**NAVAL MEDICAL RESEARCH INSTITUTE  
BETHESDA, MARYLAND**

**81 - 47**

**HUMAN ENGINEERING EVALUATION  
OF THE  
HYPERBARIC RESEARCH FACILITY  
(PHASE 1)**

Fig. 36. The 13 locations in which noise levels were measured. The higher the number, the higher the recorded noise level.

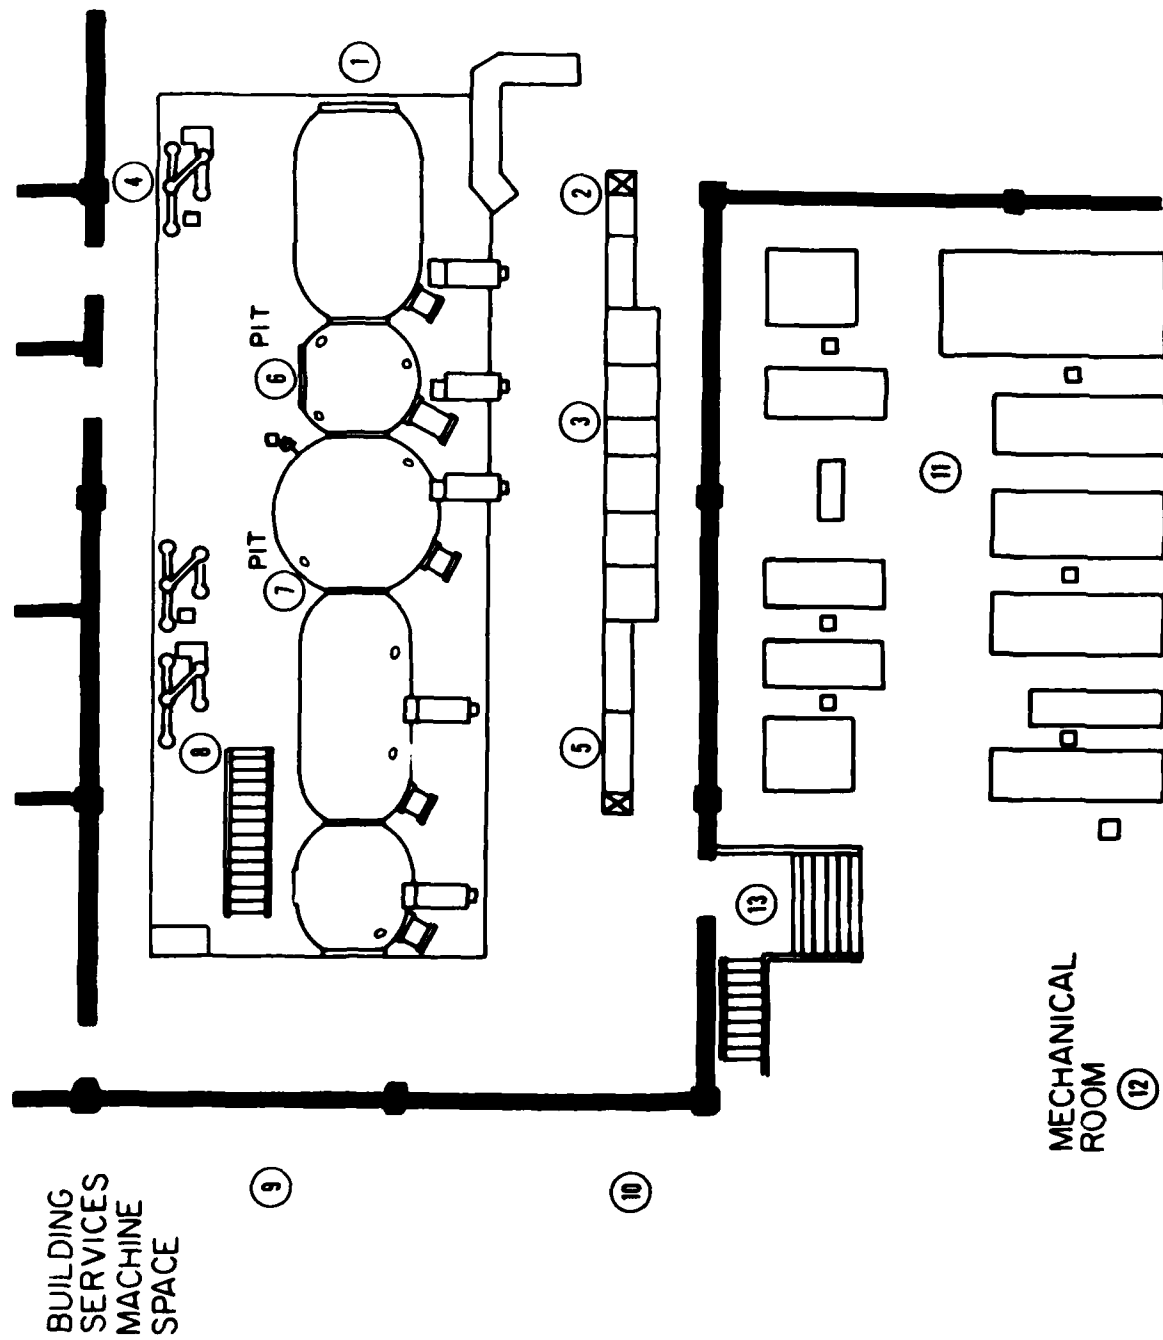
- (1) As previously mentioned, recorded noise levels in several places within the HRF approach the upper limit of the OSHA standards for an 8 h exposure. Figure 36 indicates the 13 locations where sound levels were periodically recorded. The circled numbers rank the locations from the lowest noise level [1] to the highest [13]. The lower noise levels which occur in the vicinity of the operating panels are still high enough to fatigue operators exposed to them for lengthy periods of time and to reduce communication efficiency between members of the diving watch as well as between the diving watch and divers within the chamber. The major contributors to the noise levels in the immediate chamber
